NORTH FALLS

Offshore Wind Farm

Outline Construction Traffic Management Plan (Tracked)

Document Reference: 7.16

Drawing 104560-MMD-00-XX-DR-CE-1032-1_Rev02

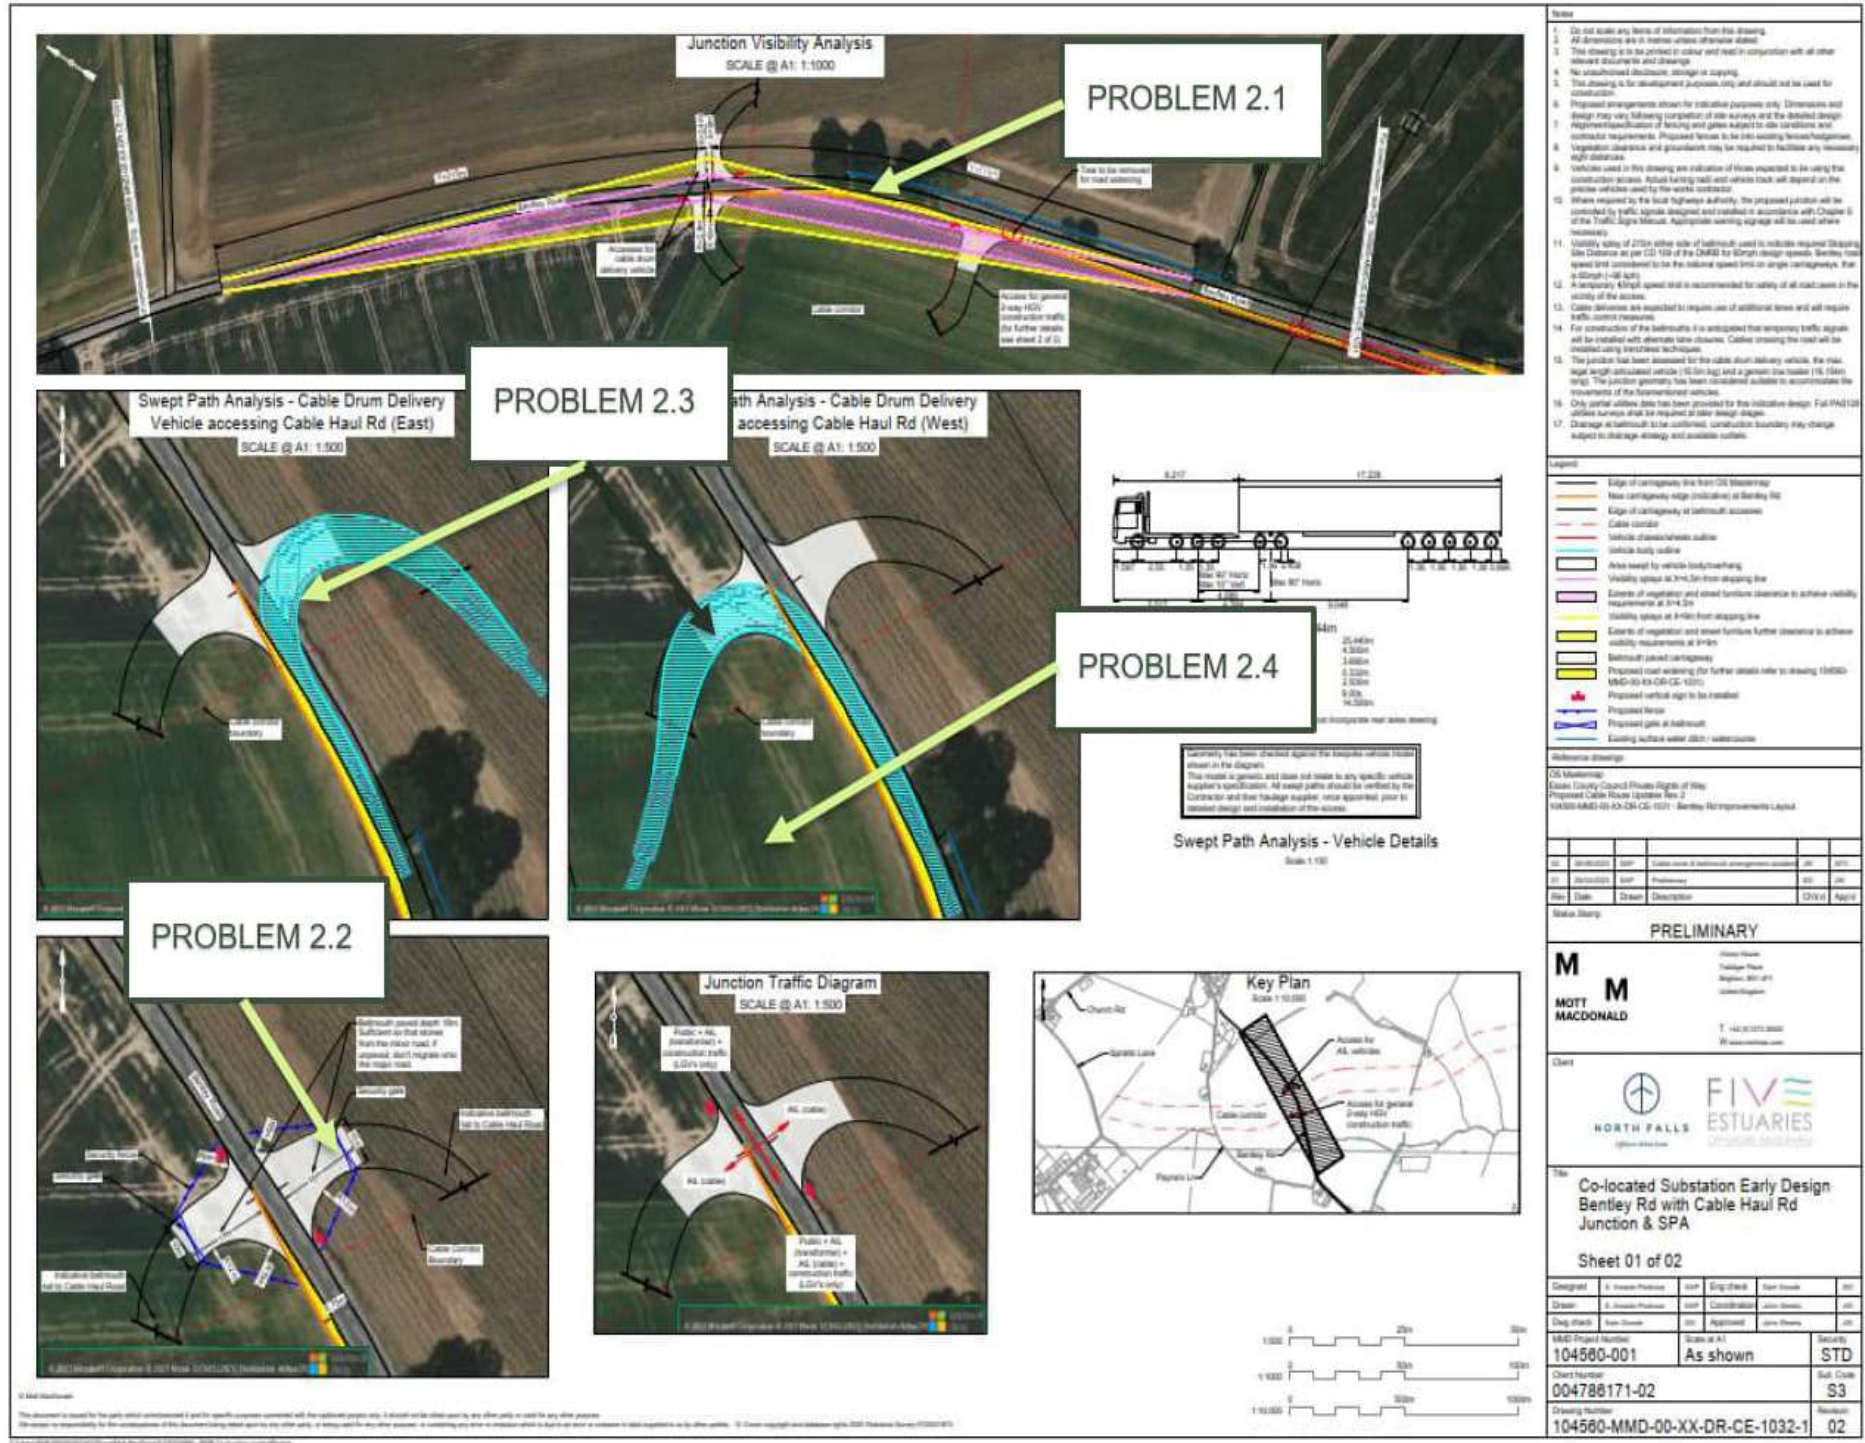
Drawing 104560-MMD-00-XX-DR-CE-1032-1_Rev02						
2.1	Location: Site Access (Temporary Access Junction with Bentley Rd). Refer to Appendix B. Summary: At a 9m setback, existing trees may obscure the visibility splay potentially leading to side swipe type collisions. Onsite observations noted that the presence of existing vegetation may constitute an obstruction to the junction visibility. Obstruction to visibility splays may lead to injudicious vehicle movements at the proposed junction leading to side swipe collisions between vehicles.	It is recommended that the trees be cut back and maintained as such that it does not pose an obstruction to the visibility splays.	● RSA problem and recommendation acknowledged but not agreed since it is not considered that these trees have an impact on the visibility clearance areas. The visibility splay with a 9m setback on the eastern side of Bentley Rd (northern side of Bentley Rd on drawing 104560-MMD-00-XX-DR-CE-1032-1) only captures a small area of road verge west of these existing trees, to run across the road to the other verge side west of Bentley Rd (South of Bentley Rd in drawing 104560-MMD-00-XX-DR-CE-1032-1). Cutting back or trimming the trees will not produce any changes to visibility. Trees are located on the southeast of the road and will cast shadow during most part of the day unless they are totally cut. ● In drawing 104560-MMD-00-XX-DR-CE-1031-3 for the same scheme (refer to Appendix C in this document), it is indicated the trimming of these existing trees to facilitate passage of vehicles, which will also help with general visibility. ● No designer action proposed.	TBC	TBC	No action (TBC).

Drawing 104560-MMD-00-XX-DR-CE-1032-2_Rev01						
2.5	Location: Proposed site access. Refer to Appendix B. Summary: The level difference between the carriageway and site could result in loss of control or side swipe type collisions. Onsite observations found that there was a difference in levels between the existing carriageway and the new access. An excessive gradient may create difficulty for large construction vehicles wishing to access Lodge Lane and may in turn lead to a lack of surface friction and slow egress movements potentially creating shunt / side swipe type collisions between egressing construction vehicles and vehicles travelling on Bentley Road.	It is recommended that the existing gradient be amended to an appropriate level for the restart movements of large vehicles accessing Bentley Road from the proposed site	- RSA problem and recommendation agreed. - This matter will be appraised further as an integral part of the detailed design process and drawings developed to take due account of the safety problem and the aligned recommendation.	TBC	TBC	This matter will be appraised further as an integral part of the detailed design process and drawings developed to take due account of the safety problem and the aligned recommendation. (TBC)

Ref.	RSA Problem	RSA Recommendation	Design Organisation Response	Audit Team Supplementary Comment	Client / Project Sponsor Comment	Agreed RSA action
			envelope, fits within the bellmouth outlines. The chassis envelope line will be brought forward in the drawing for clarity. - Also please note that vehicle models used to perform the SPA are conservative and representing a worst case scenario. We can conclude that if the vehicle chassis swept path fits within the carriageway limits with these conservative vehicle models (as it does), room is to be sufficient in reality. - Note 9 in drawing 104560-MMD-00-XX-DR-CE-1032-1_Rev02 («Vehicles used in this drawing are indicative of those expected to be using this construction access. Actual turning radii and vehicle track will depend on the precise vehicles used by the works contractor») and disclaimer shown in Vehicle Details («This model is generic and do not relate to any specific vehicle supplier's specification. All swept paths should be verified by the Contractor and their haulage supplier, once appointed, prior to detailed design and installation of the access») were included as caveats in relation to this matter.

Drawing 104560-MMD-00-XX-DR-CE-1070_Rev01

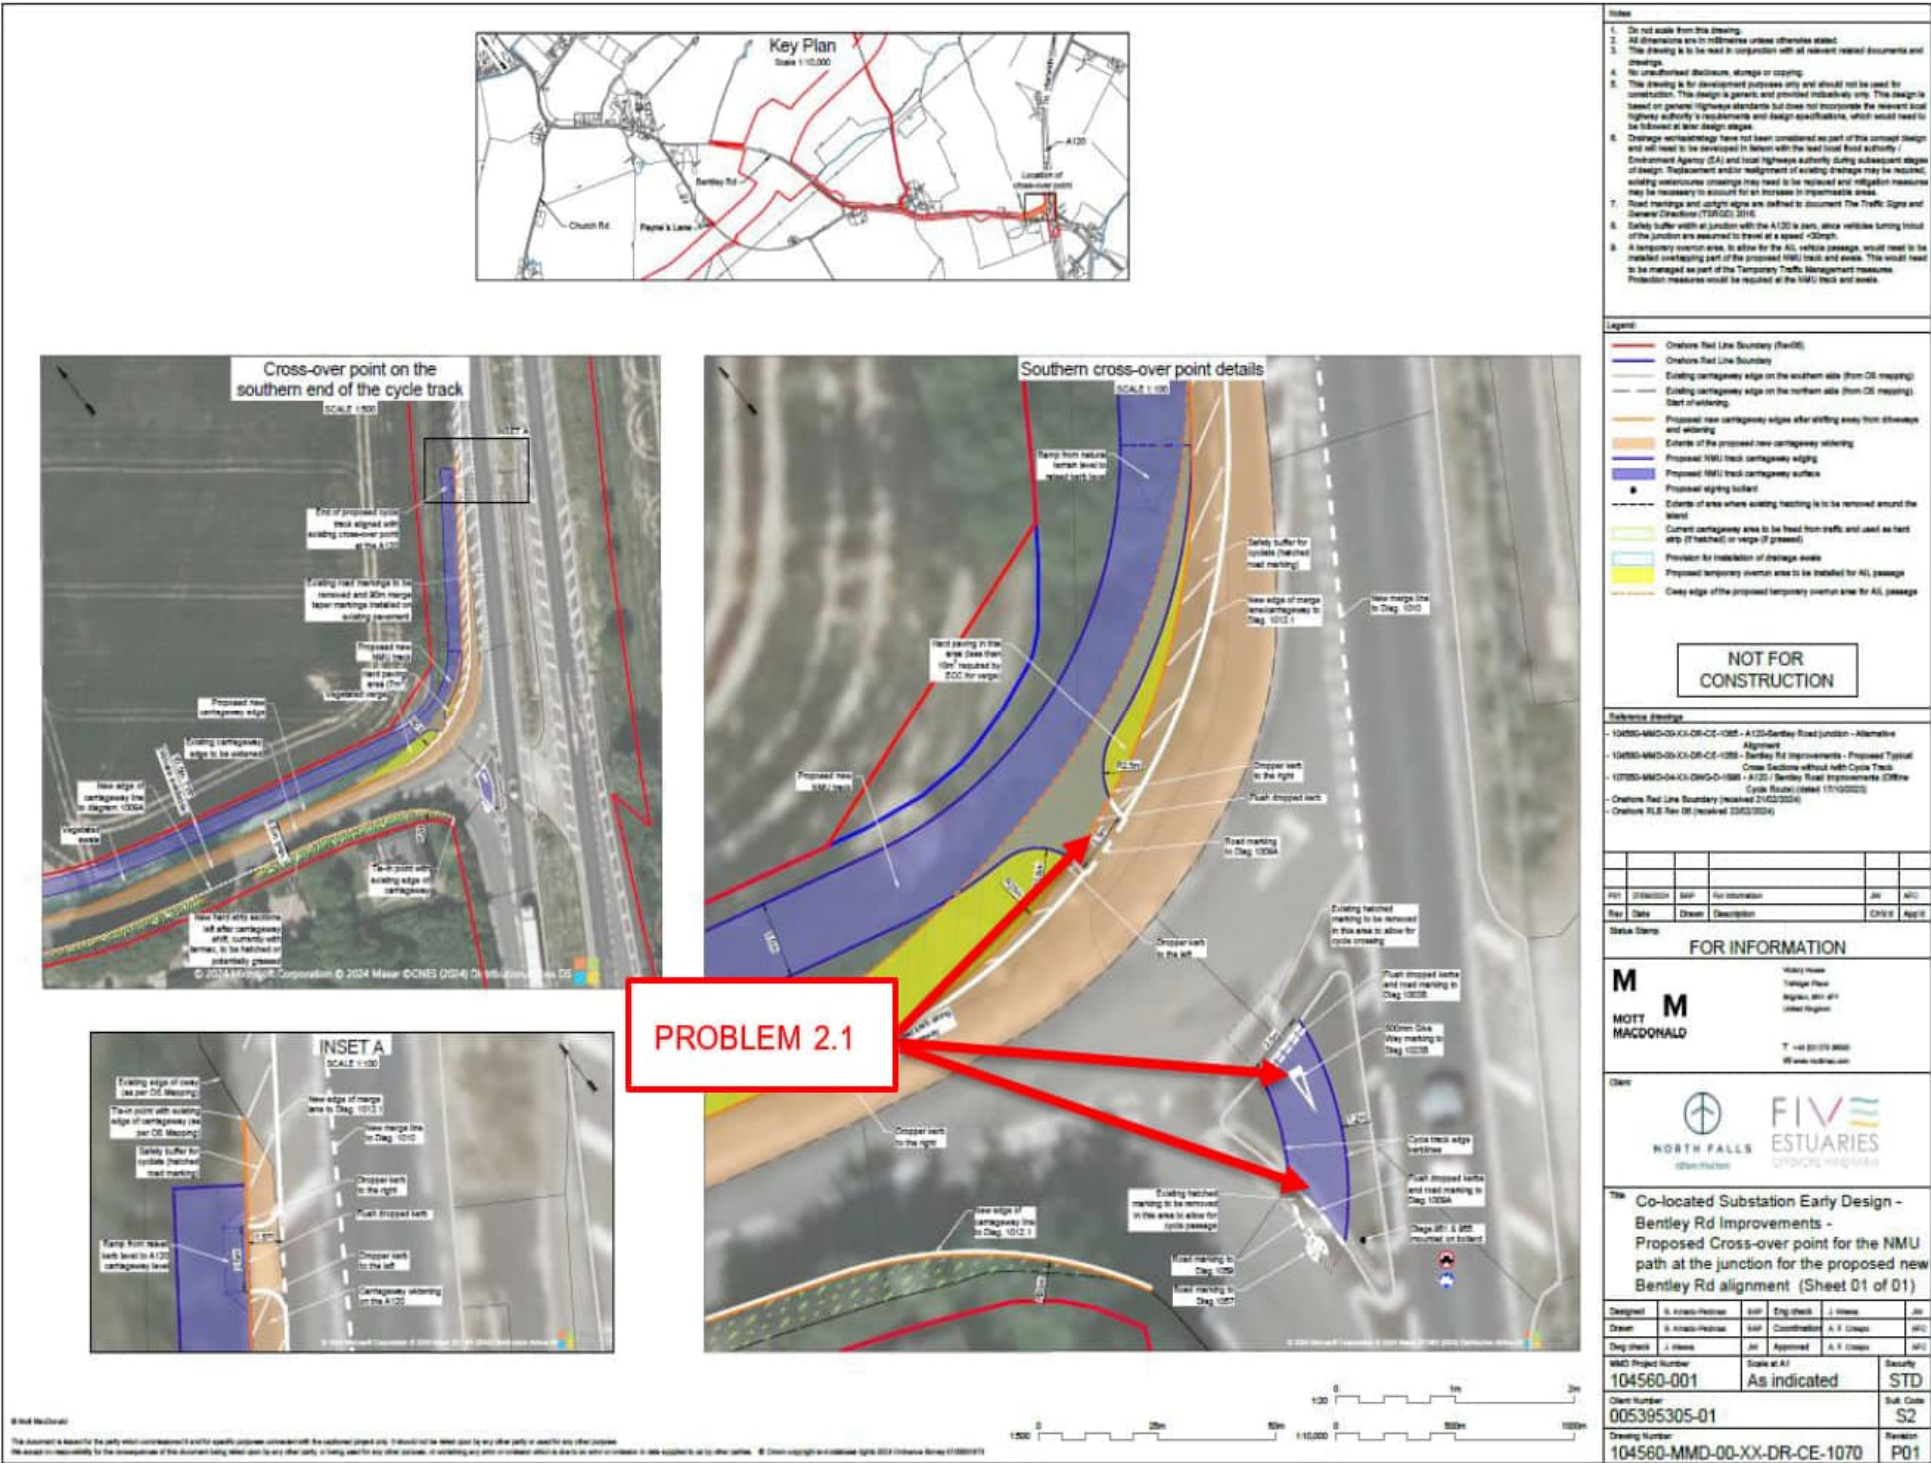
Drawing 104560-MMD-00-XX-DR-CE-1070_Rev01						
2.1	Location: A120/Bentley Rd Junction. Summary: Lack of hazard warning tactile paving provided at dropped kerbs leading to the NMU route may lead to collisions between NMUs and vehicular traffic. Design drawings show an extension of the NMU route adjacent to the A120. An existing splitter island will be amended with dropped kerbs and road markings to allow NMU users to leave the A120 Northwest bound. This design is not shown complete with hazard warning tactile paving that would alert NMUs particularly those with visual impairments that they are about to enter the vehicular carriageway. This arrangement may in turn lead to collisions between NMUs and vehicular traffic.	It is recommended that any access points to the vehicular carriageway are provided with the appropriate tactile paving installations.	● RSA problem acknowledged but recommendation partially dismissed due to the crossover movement only being allowed to northbound cycles and cycle access points to/from the carriageway not requiring the installation of tactile pavement. ● To provide greater clarity to the crossing movements allowed at this crossover point and to improve safety, both for pedestrians and cycles, a segregated shared use section of the NMU track is to be added along the area of concern to direct pedestrians away from the crossover. Tactile pavement is to be installed at the start and end of this segregated shared use section of the NMU track, in line with the Department for Transport document: <i>Guidance on the Use of Tactile Paving Surfaces</i>, Section 5. Ladder tactile pavement shall be installed at the start/end of the pedestrian way within the NMU track for a depth of 2.4m each, and width of 1.5m (width of the pedestrian way). Tramline tactile pavement shall be installed at the start/end of the cycle way within the NMU track for a depth of 2.4m each, and width of 2m (width of the cycle way). The ladder and tramline tactile pavement will assist vision impaired people. Diagrams 956 & 957 mounted on bollards and installed at the start/end of the segregated shared use section of the NMU track would also assist all other users. The installation of Diagrams 956 & 957 is a recommendation within <i>Guidance on the Use of Tactile Paving Surfaces</i>, Section 5 and LTN 1/20 paragraph 9.4.3, however their installation shall be discussed with the ECC LHA to avoid sign clutter. ● The segregated shared use NMU track will direct pedestrians away from the crossover point at the junction, greatly reducing the risk of pedestrians trying to cross. ● It is also proposed that the carriageway at the cycle area of the segregated shared use NMU track is surfaced in a different colour than the rest of the NMU track, to make it more conspicuous to all users. ● Additionally, the corner radii at the NMU track leg leading to the trafficked carriageway have been reduced to R=1m and the leg width, to 2.5m, except at the corner radii, to reduce comfort at making the turn. Edge of lane road markings have been proposed at the intersection of this leg with the NMU mainline cycle track and directional arrow road markings to emphasize the one-way character of this cycle track leg. ● This matter will be appraised further, in conjunction with the Local Highways Authority, as an integral part of the detailed design process, when bespoke signing and road marking drawings and specifications are to be agreed and produced for the preferred solution.	To be populated by the Audit Team	To be populated by the Client / Project Sponsor	This matter will be appraised further, in conjunction with the Local Highways Authority, as an integral part of the detailed design process, when bespoke signing and road marking drawings and specifications are to be produced for the agreed preferred solution. All measures to increase safety, described at the Design Organisation Response column, to be added to drawing 104560-MMD-00-XX-DR-CE-1070_Rev02.

Drawing 104560-MMD-00-XX-DR-CE-1066_Rev02

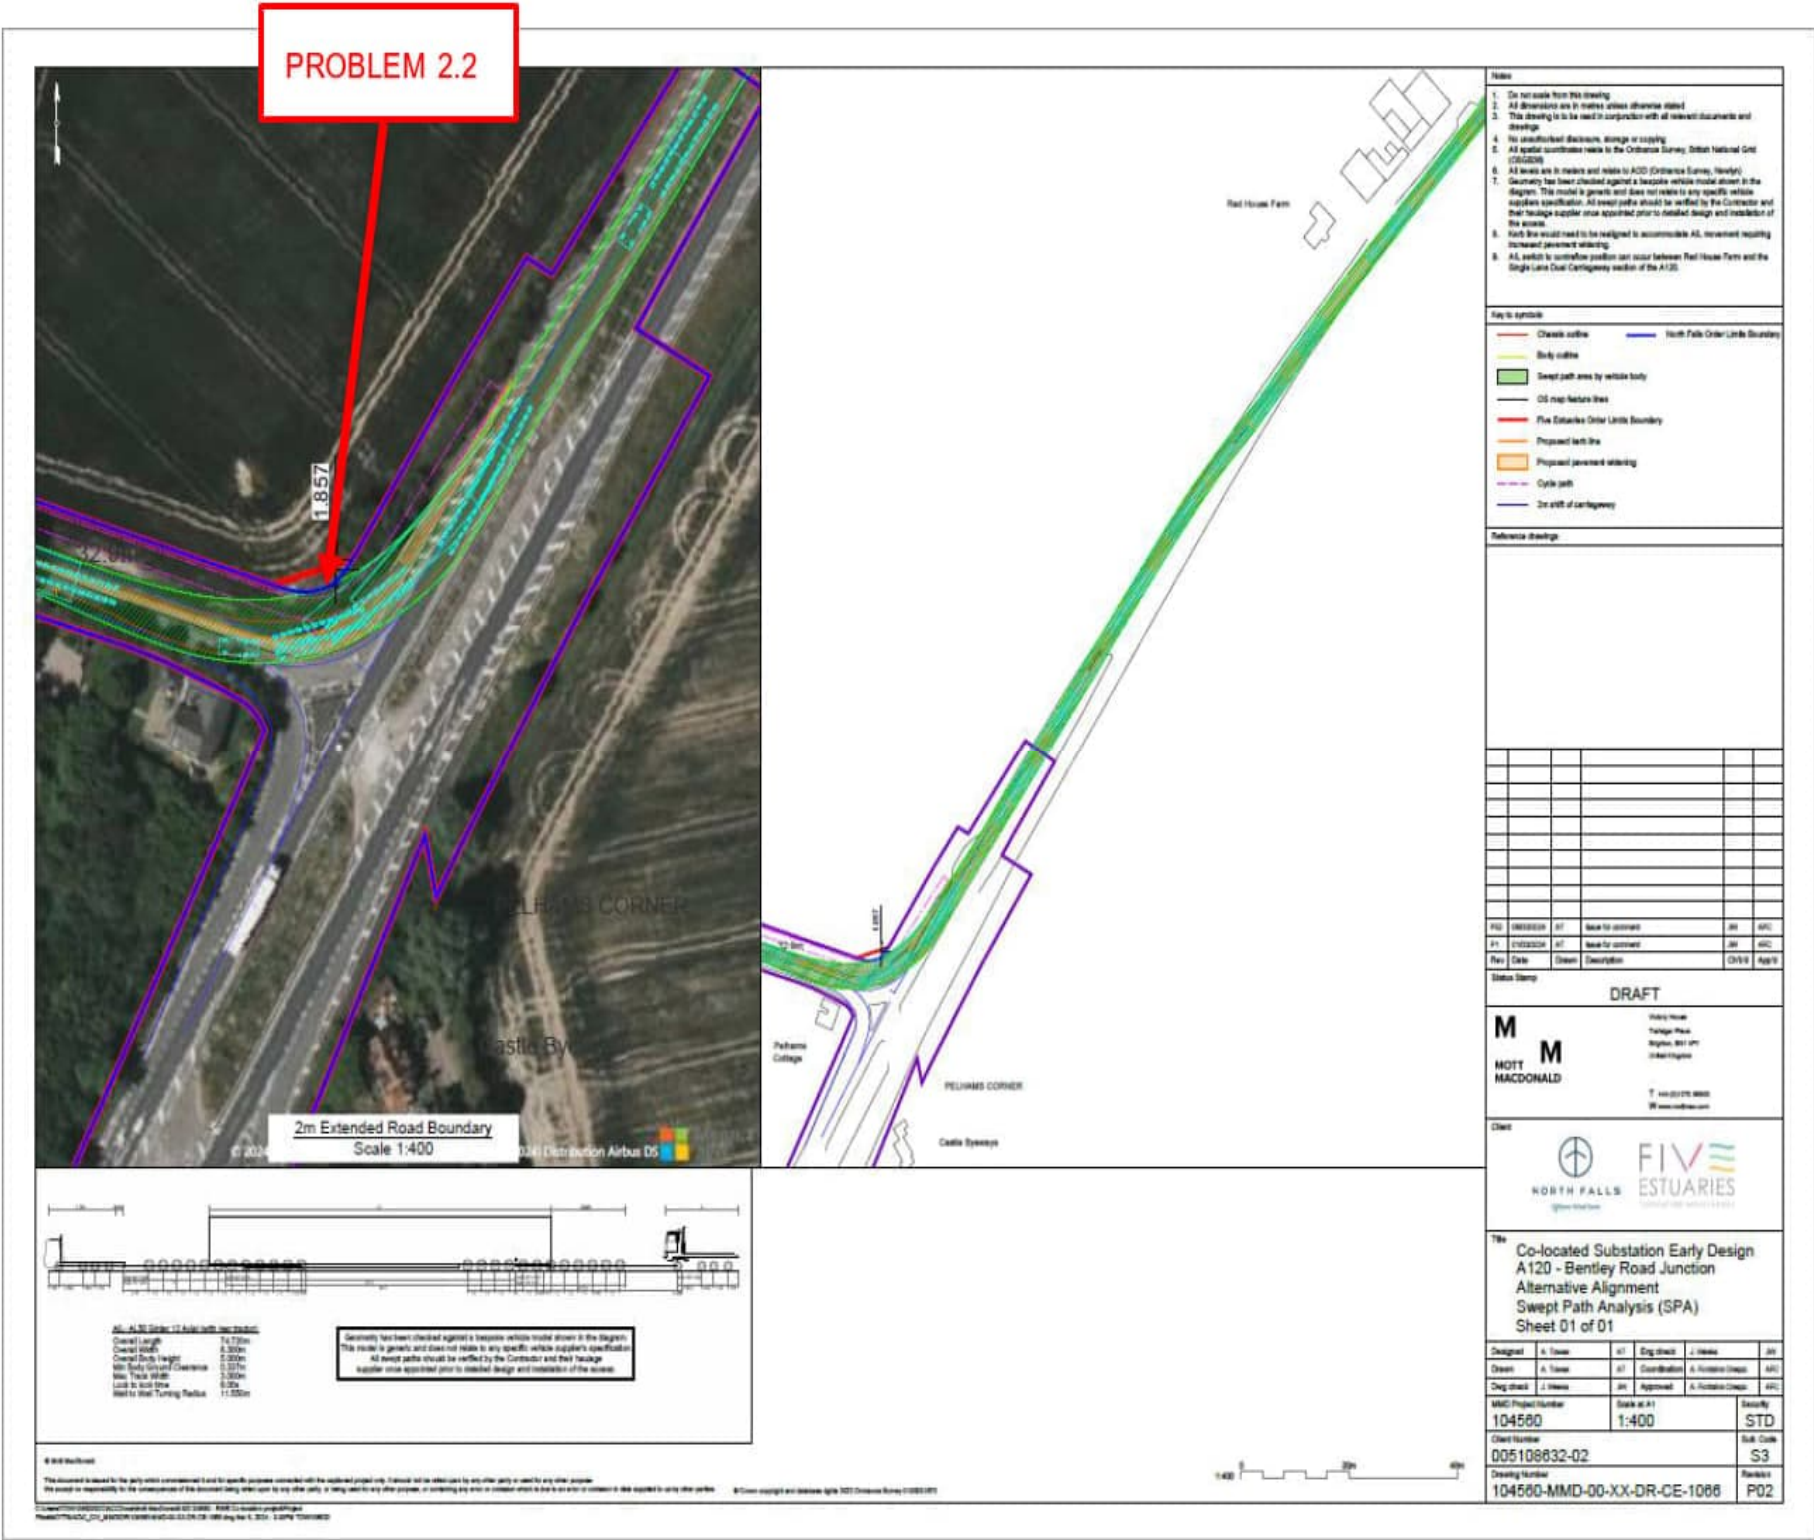
Drawing 104560-MMD-00-XX-DR-CE-1066_Rev02						
2.2	Location: A120/Bentley Rd Junction. Summary: Overrun of Exceptional 74.720m HGV into NMU corridor. Design drawings show swept path analysis of a multi axle drawbar HGV entering Bentley Road from the A120. The analysis drawing indicates that the body of this exceptional HGV will over sail the new NMU route as the vehicle turns from the A120 onto Bentley Road. This	It is recommended that banks persons are used where HGVs are required to make turns along the route to ensure that pedestrians and vulnerable road users are separated from large vehicle turning movements.	● RSA problem acknowledged and recommendation agreed. ● The use of banks persons is implicit within the Temporary Traffic Management measures to be agreed with the Local Highways Authority. These TTM measures shall be detailed at a later stage of the project. ● A note specifying the use of banks persons shall be added to drawing 104560-MMD-00-XX-DR-CE-1066_Rev03 for clarity.	To be populated by the Audit Team	To be populated by the Client / Project Sponsor	A note specifying the use of banks persons shall be added to drawing 104560-MMD-00-XX-DR-CE-1066_Rev03 for clarity. TTM measures shall be detailed and agreed with the LHA at a later stage of the project.
